Subject: Class 1 Permit Modification Notification, Waste Isolation Pilot Plant Hazardous Waste Facility Permit Number: NM4890139088-TSDF

- Completion of Panel 8 Mining

Class 1 Permit Modification Notification

Completion of Panel 8 Mining

Figure G-6
Approximate Locations of Boreholes in Relation to the WIPP Underground

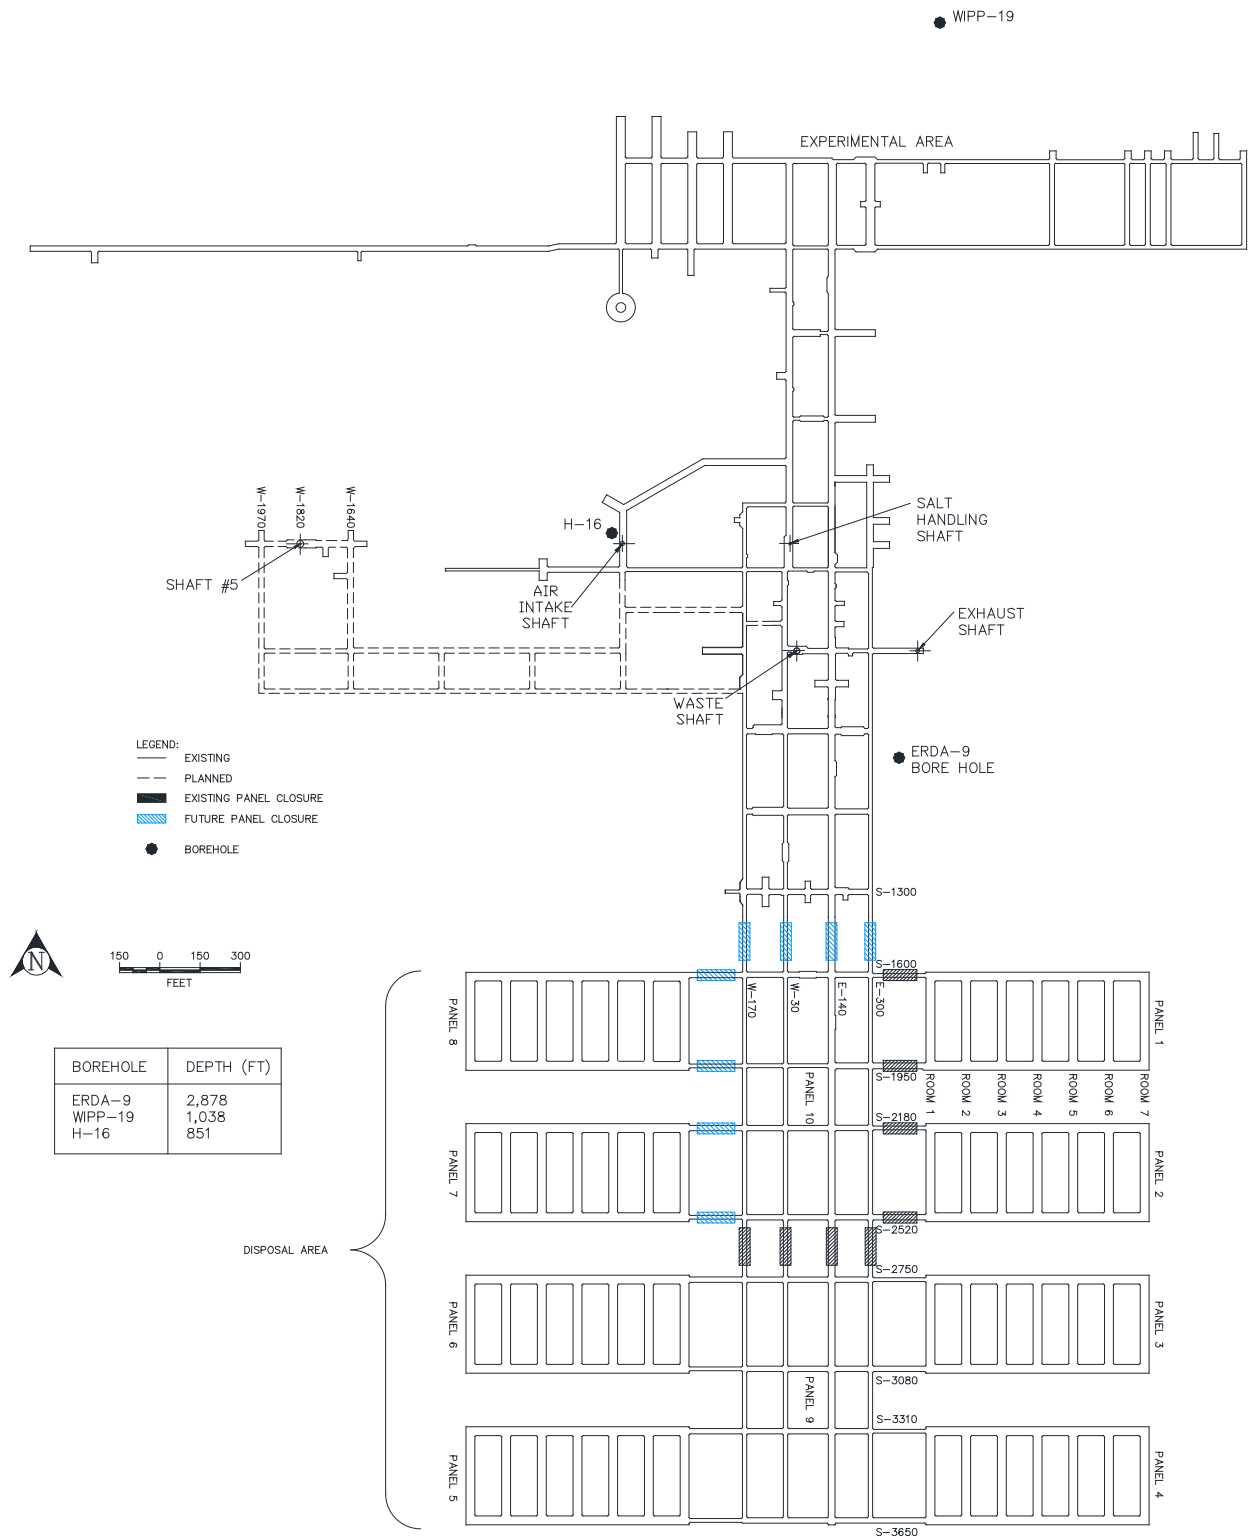
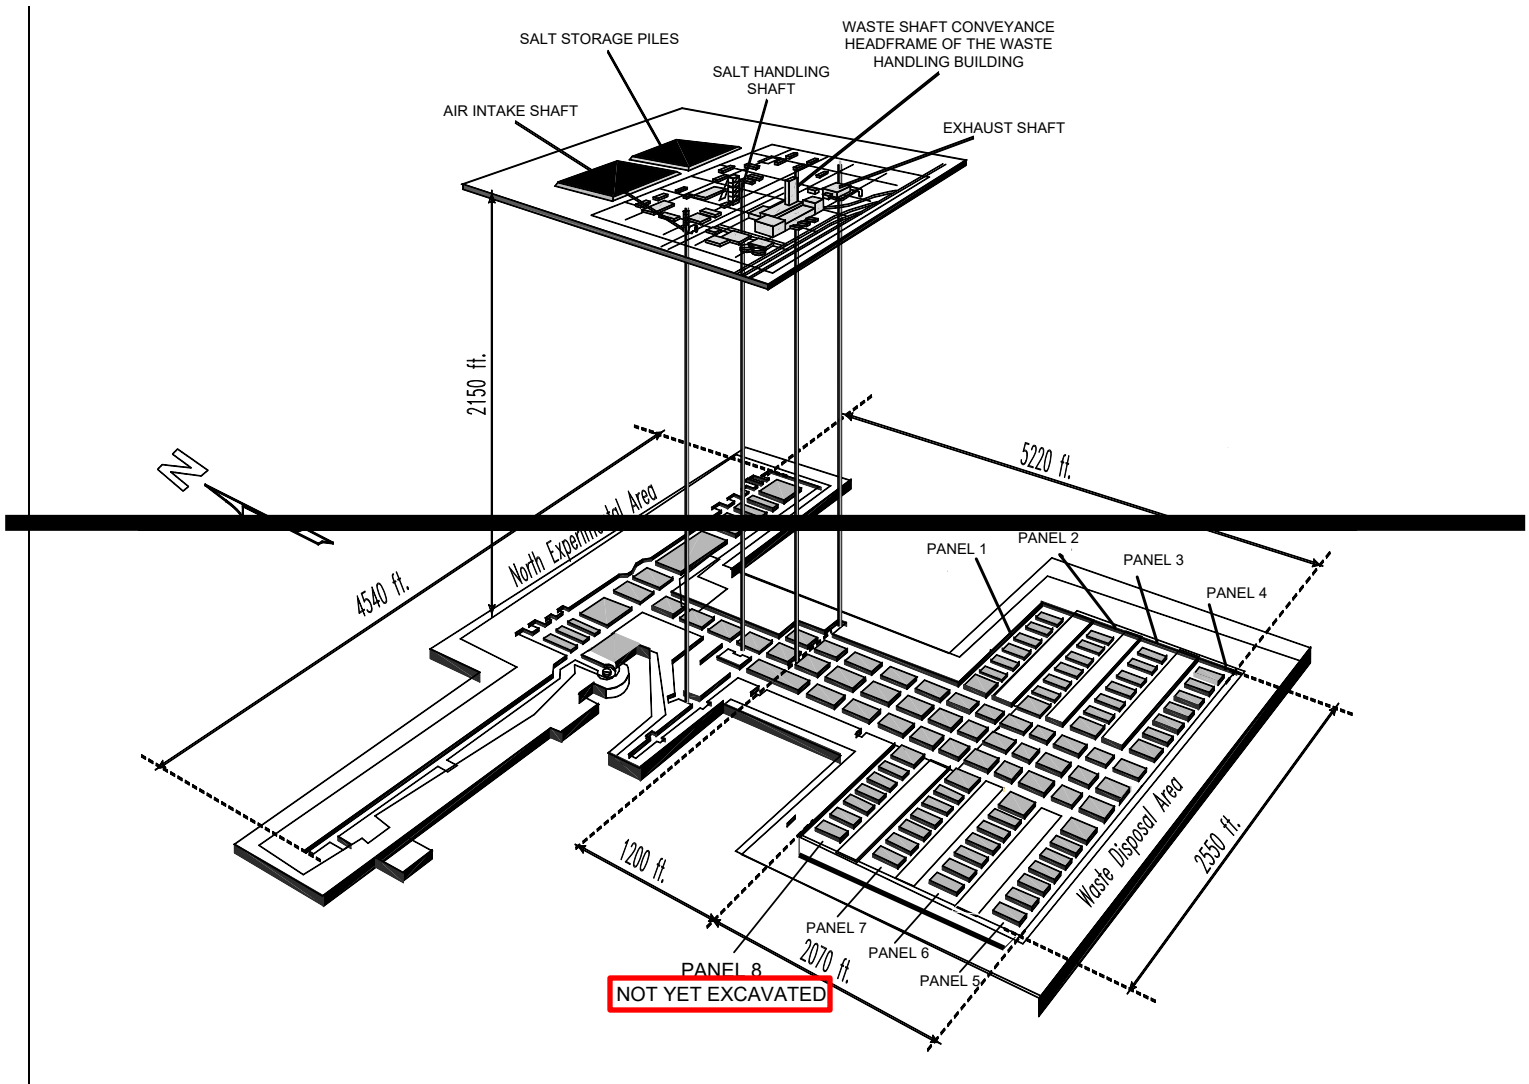
- Permit Attachment G, Figure G-6, *Approximate Locations of Boreholes in Relation to the WIPP Underground*
 - Changed Panel 8 dashed lines into solid lines.

- Deleted the following figure text: “NOTE: PANEL 8 IS CURRENTLY BEING MINED” because Panel 8 status has changed from planned to existing.
- Permit Attachment G2, Figure G2-1, *View of the WIPP Underground Facility*

Figure G2-1
View of the WIPP Underground Facility

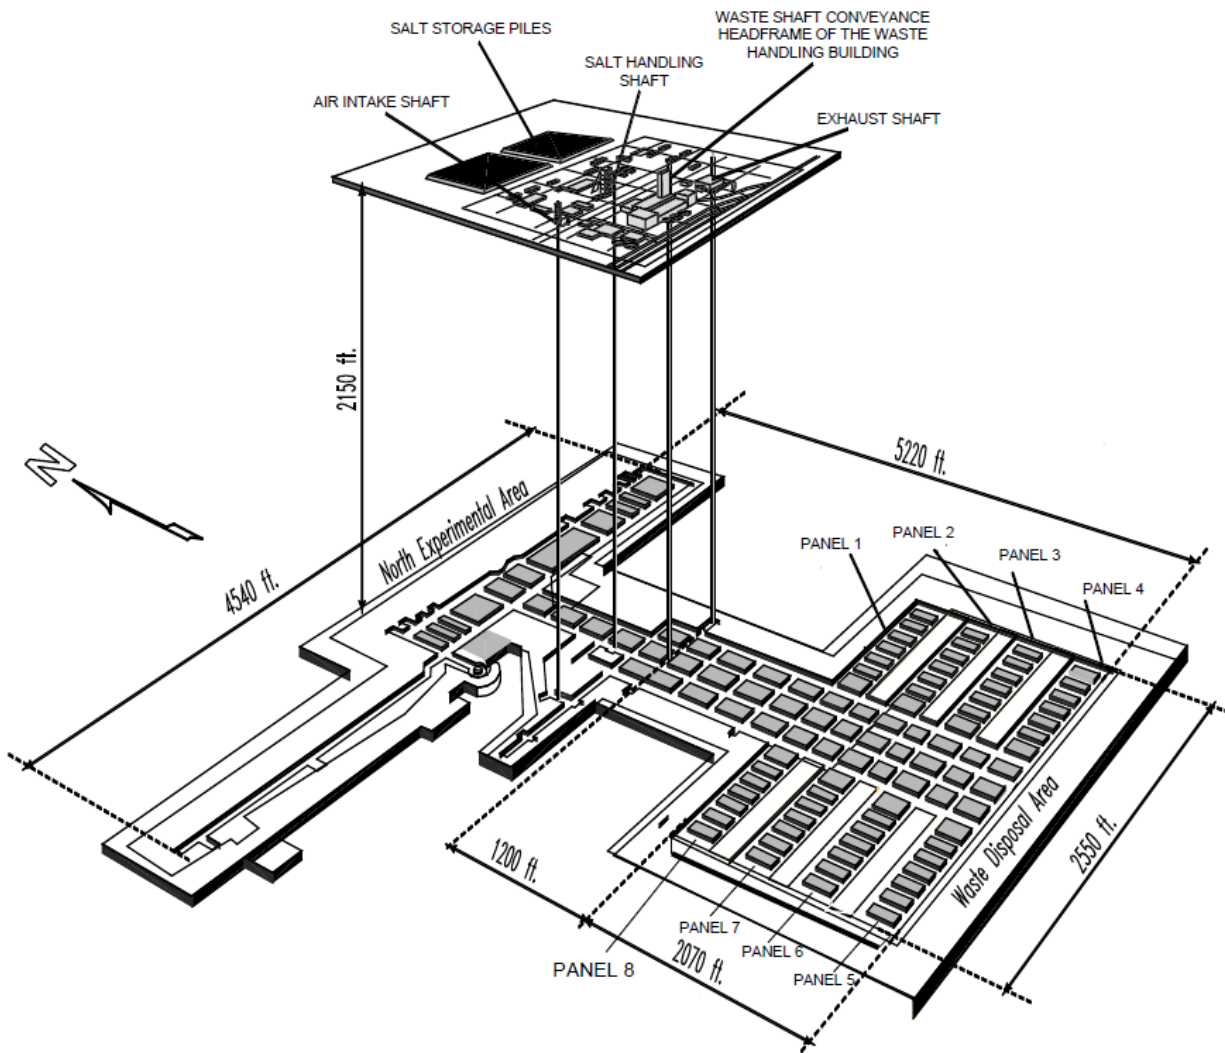
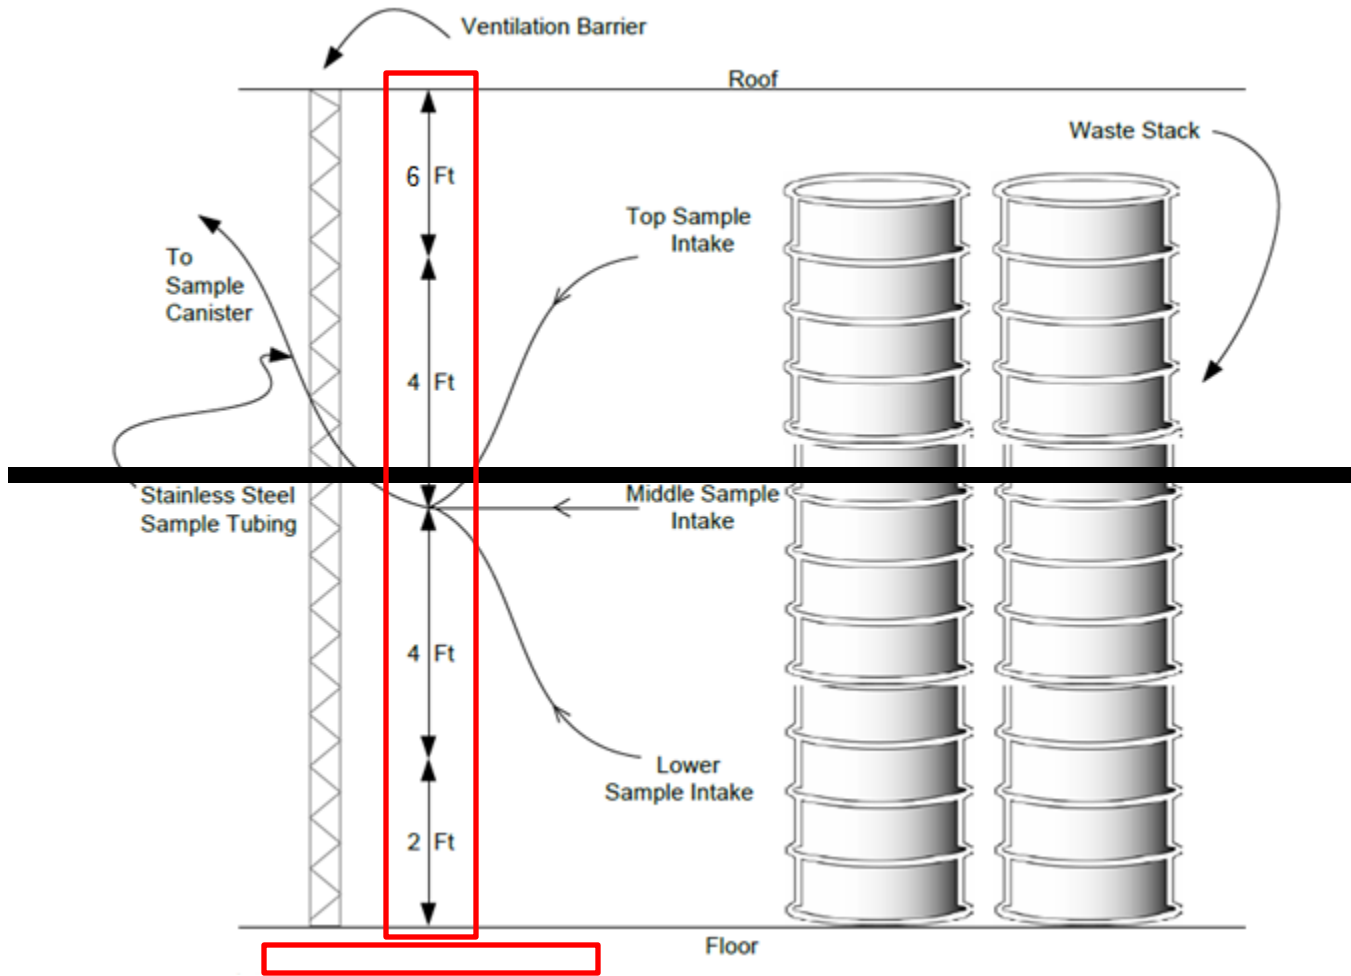
- Deleted the following figure text: “NOT YET EXCAVATED” because Panel 8 excavation has been completed.
- Permit Attachment K, Table K-4, *Hazardous Waste Management Units*

Figure N-4b
Disposal Room Sample Head Arrangement for Panel 8

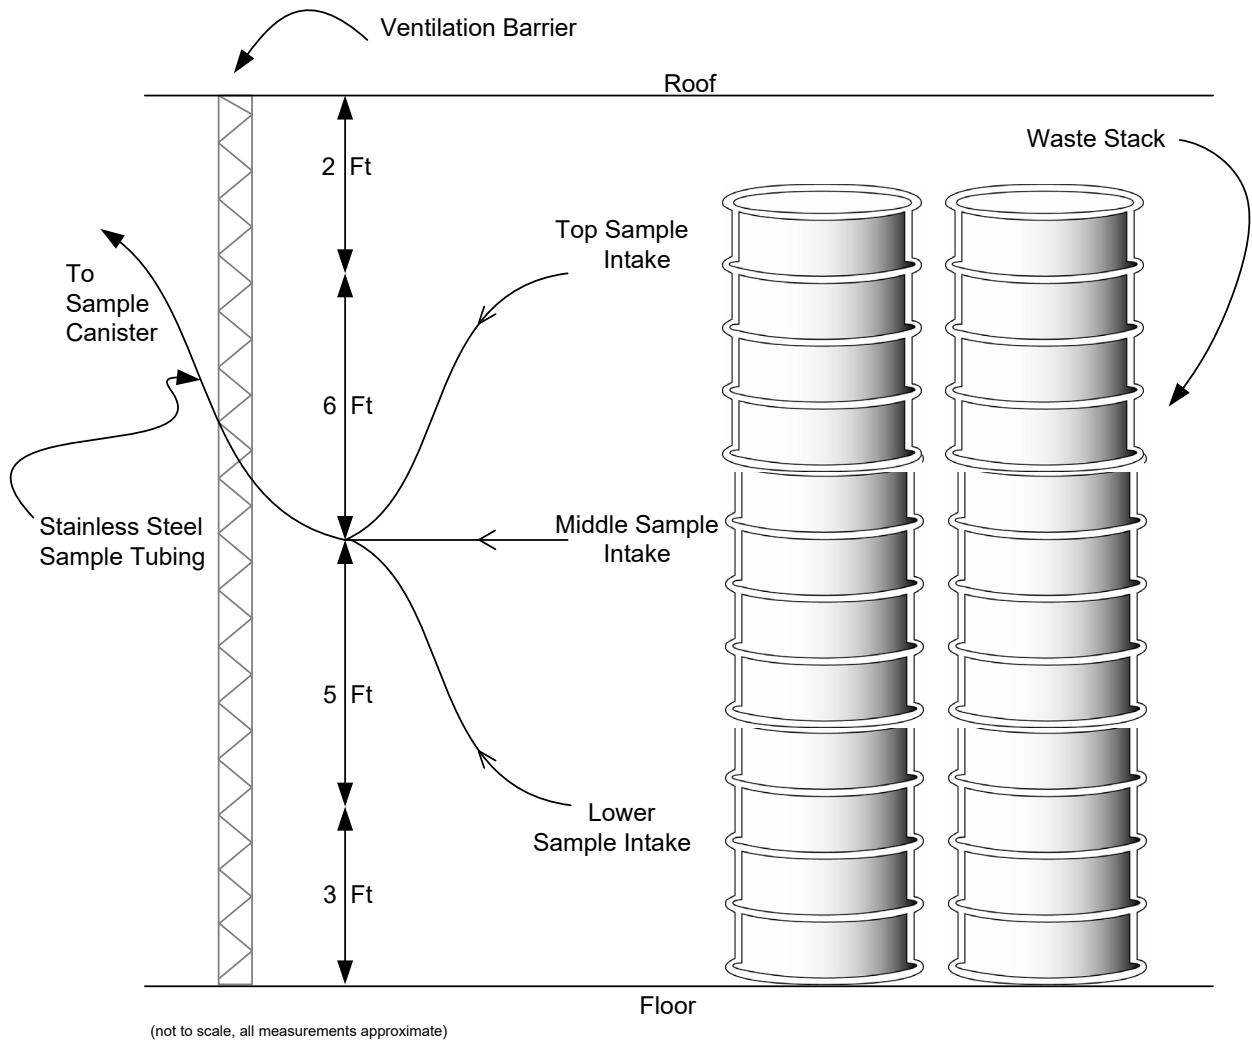
- Changed “6 Ft” to “2 Ft.”
 - Changed “4 Ft” to “6 Ft.”
 - Changed “4 Ft” to “5 Ft.”
 - Changed “2 Ft” to “3 Ft.”
 - Added the following note: “(not to scale, all measurements approximate).”
